Republic Wind Project

AGENCY CORRESPONDENCE

Based upon the revised project boundary map received on 2 April 2010, the Ohio Department of Natural Resources Division of Wildlife (DOW) has prepared these survey recommendations for the proposed Nordex wind energy project located in Seneca County. After reviewing the project area map provided and site visits conducted within that region, the DOW has determined that this proposed facility would be classified as a "moderate" site under the current monitoring protocols (Fig. 1).

Re: Nordex Republic Wind Project, Seneca County

Figure 1. Survey effort map with revised boundary for Nordex's proposed Republic project.

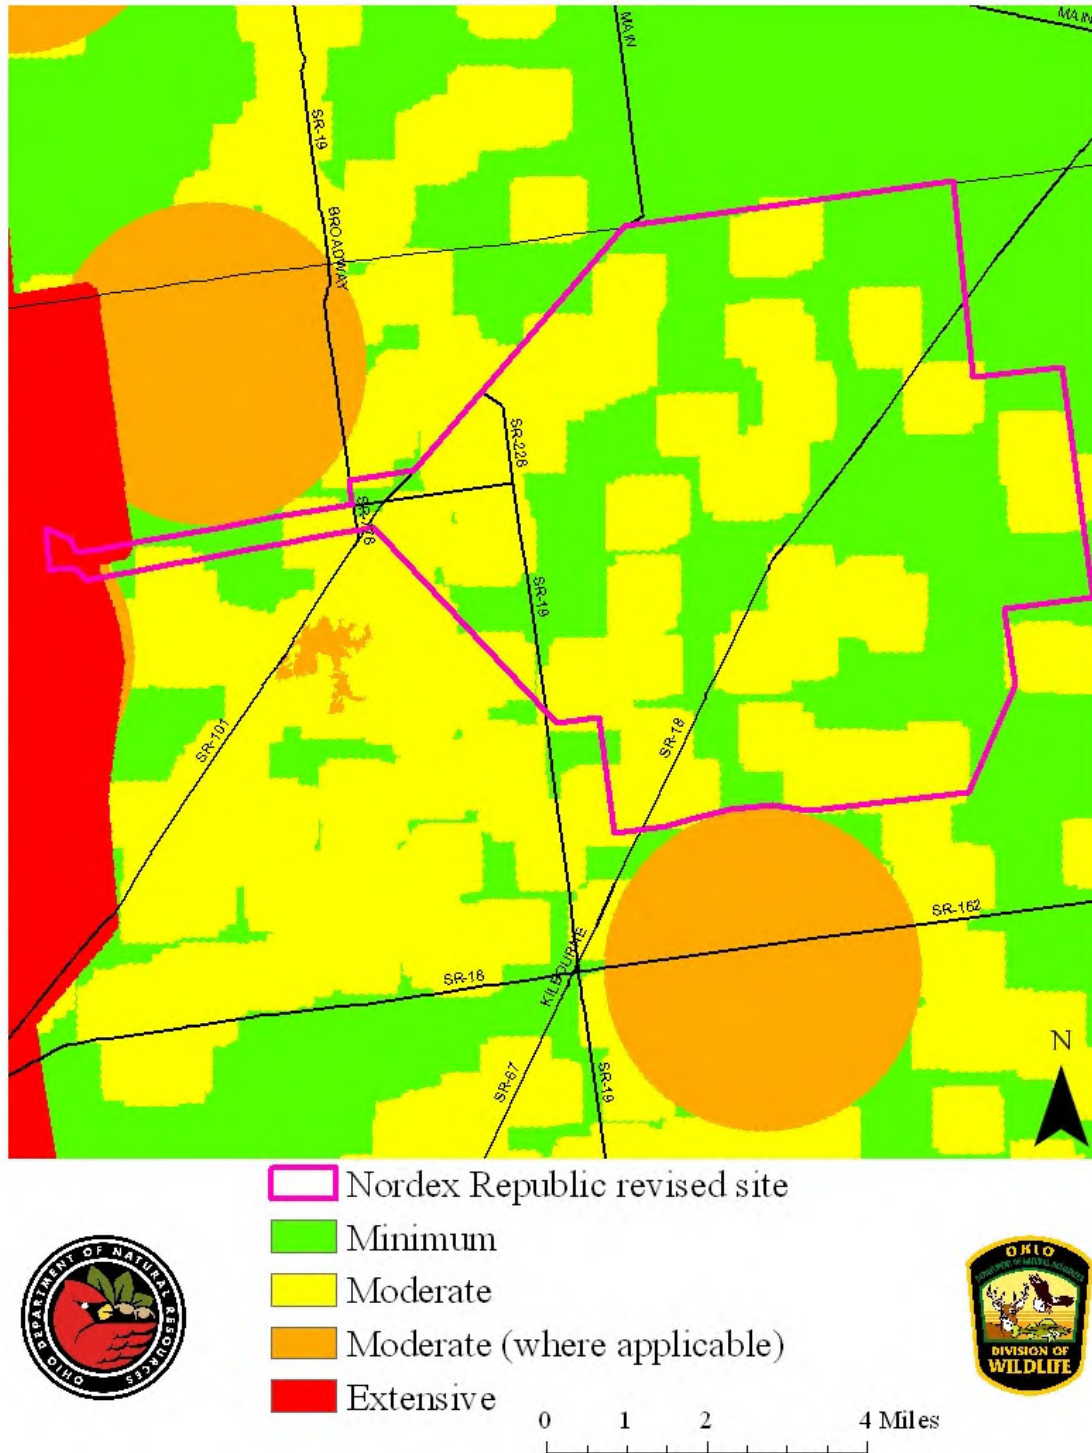
Based upon the updated project boundary map received on 8 February 2011, the Ohio Department of Natural Resources Division of Wildlife (DOW) has prepared these revised survey recommendations for Nordex's proposed project located in Seneca County.

Currently the project falls within regions that DOW has identified as needing extensive monitoring efforts. If the developer decides to amend the boundaries or based upon DOW site visit, the DOW will revise our survey recommendations.

Survey effort map with the revised boundary for Apex's proposed Republic project (October 2017).

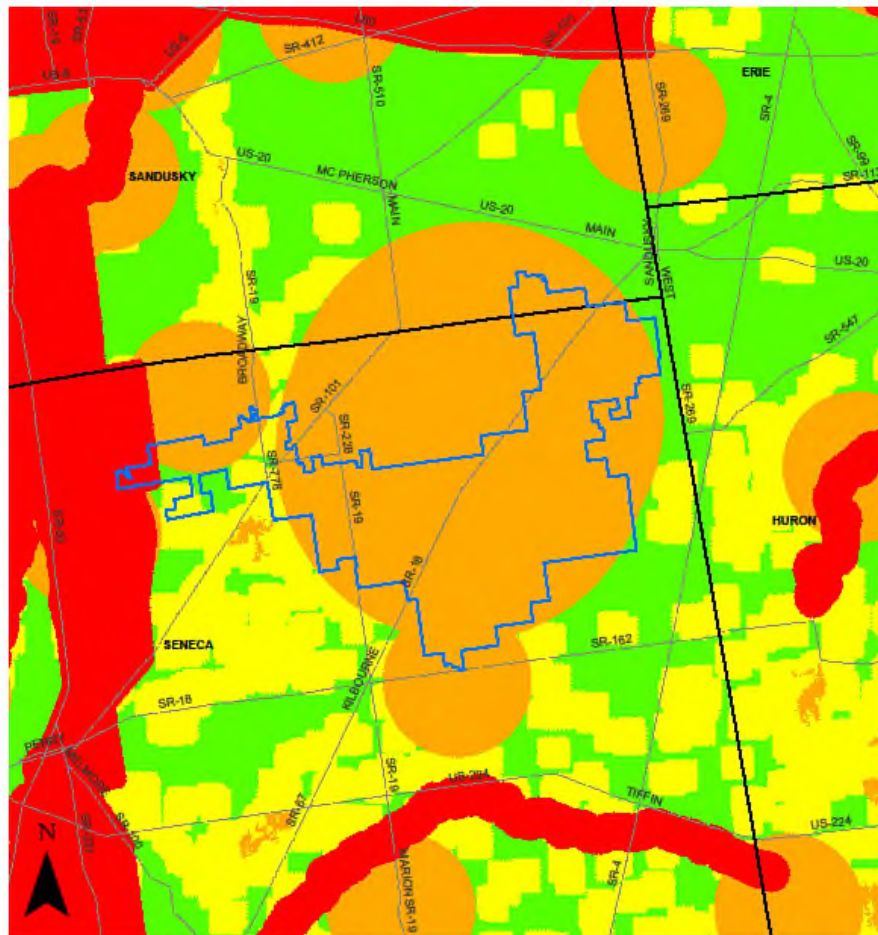
Based upon the project boundary map received October 2017 and further review of the project area, the Ohio Department of Natural Resources Division of Wildlife (DOW) has updated the June 8, 2011 initial survey recommendations for Apex's proposed Republic project located in Seneca and Sandusky counties regarding wildlife species.

The project should follow the "moderate" survey effort protocol as described within the "On-shore Bird and Bat Pre- and Post-Construction Monitoring Protocol for Commercial Wind Energy Facilities in Ohio." If the developer decides to amend the current boundaries, the DOW will revise our survey recommendations.

Republic: Eagle Nests

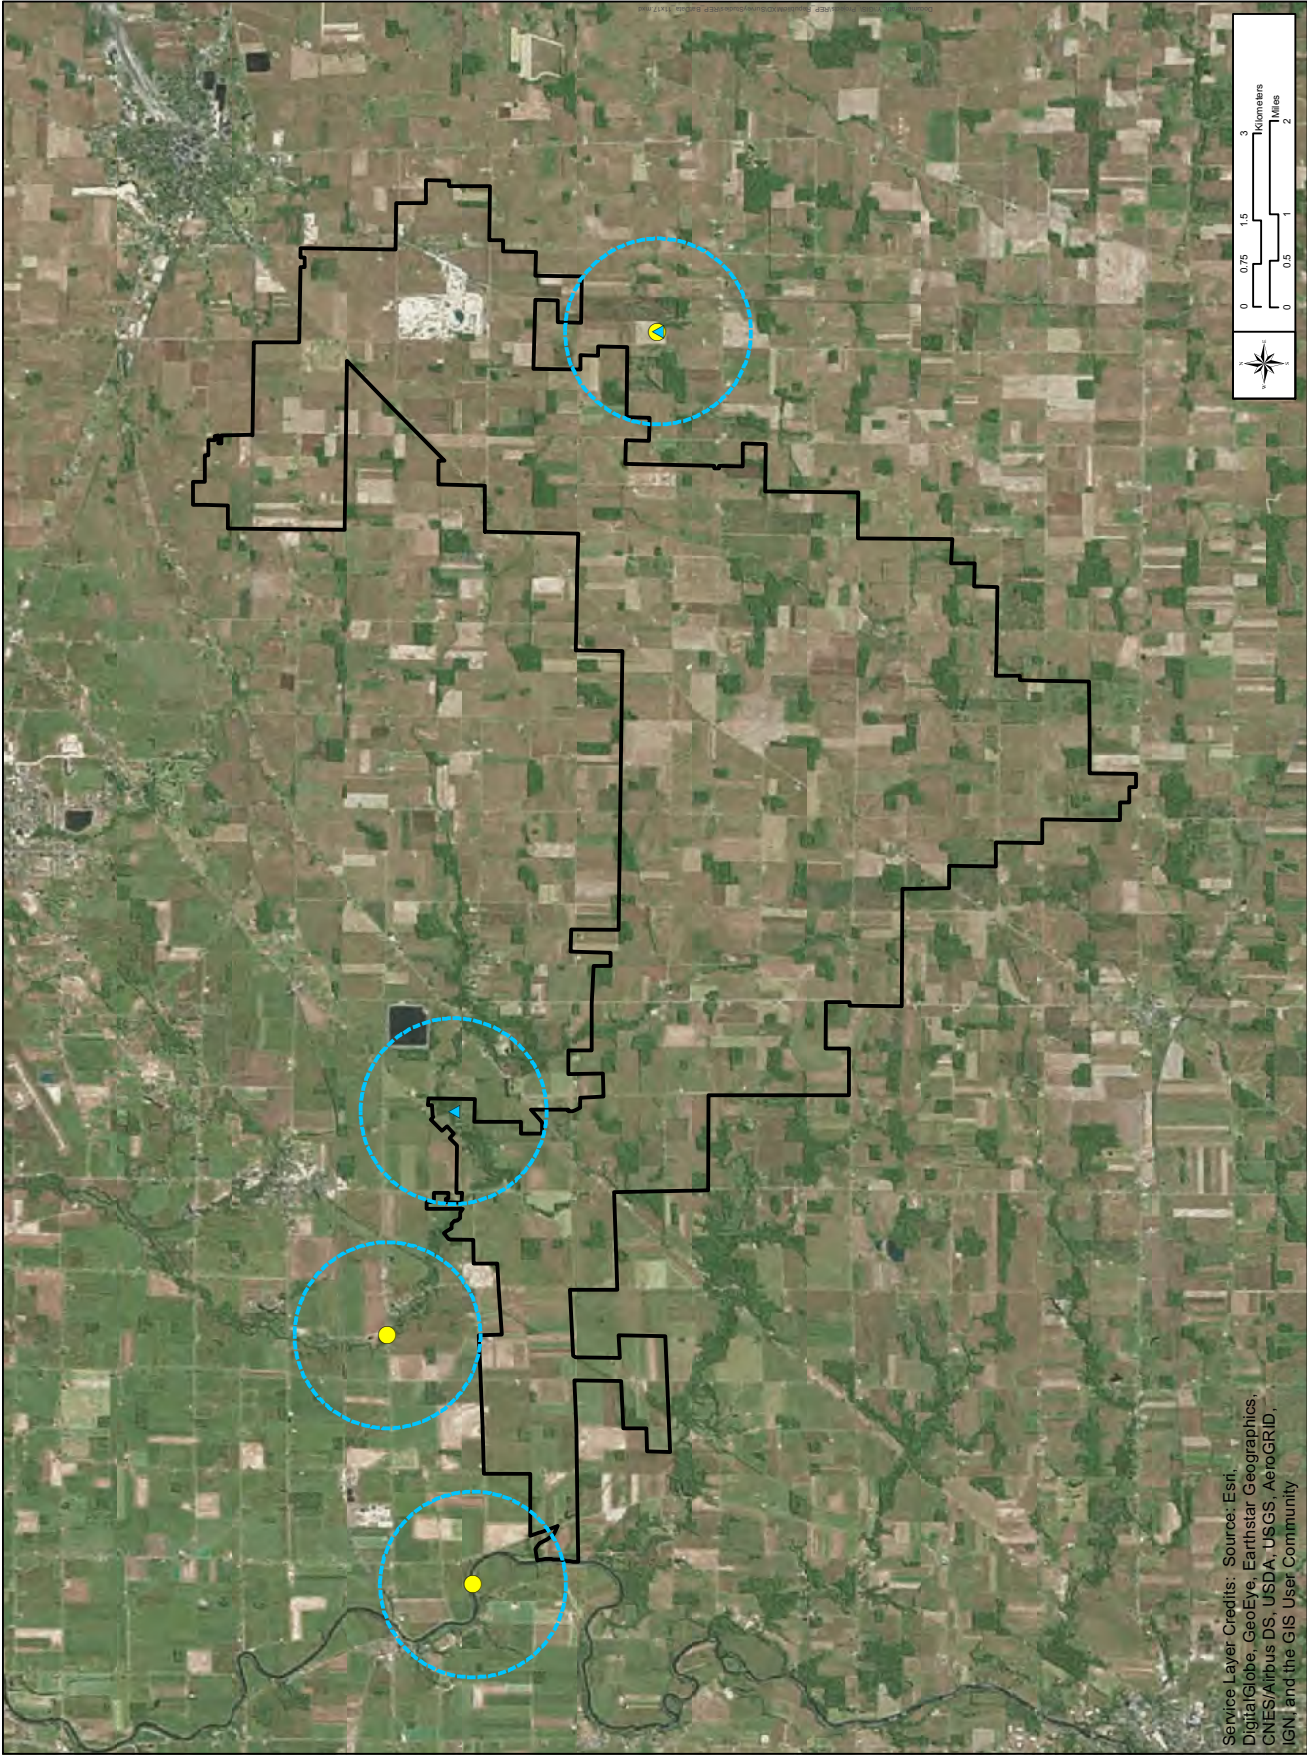
Thank you for your email. As requested, I have attached a map of the current Republic boundary and the location of all known eagle nests in proximity to the Project. The new nest in the NW portion of the Project is still within the official Project boundary; however, no turbines are planned within 1.9 miles of the nest. We were unable to completely remove the nest from the boundary as we are still considering two transmission line options, one of which would run along the western boundary of the parcel where the nest is located (approximately 0.4 miles from nest).

I got your message regarding how Apex plans on changing their project boundary in response to the discovery of a new eagle nest in the western portion of the project. When they are available I'd still like to see a map of the revised project boundary and the location of the new nest. I did talk to Chris Mensing from our East Lansing Field Office, he's directly involved in the eagle protocols and is willing to meet with Apex once we assess the revised project boundary and it's relationship to the new nest.

I calculated the revised 1/2 inter-nest distance this morning. Based on the revised project boundary the new value is 1.17 miles.
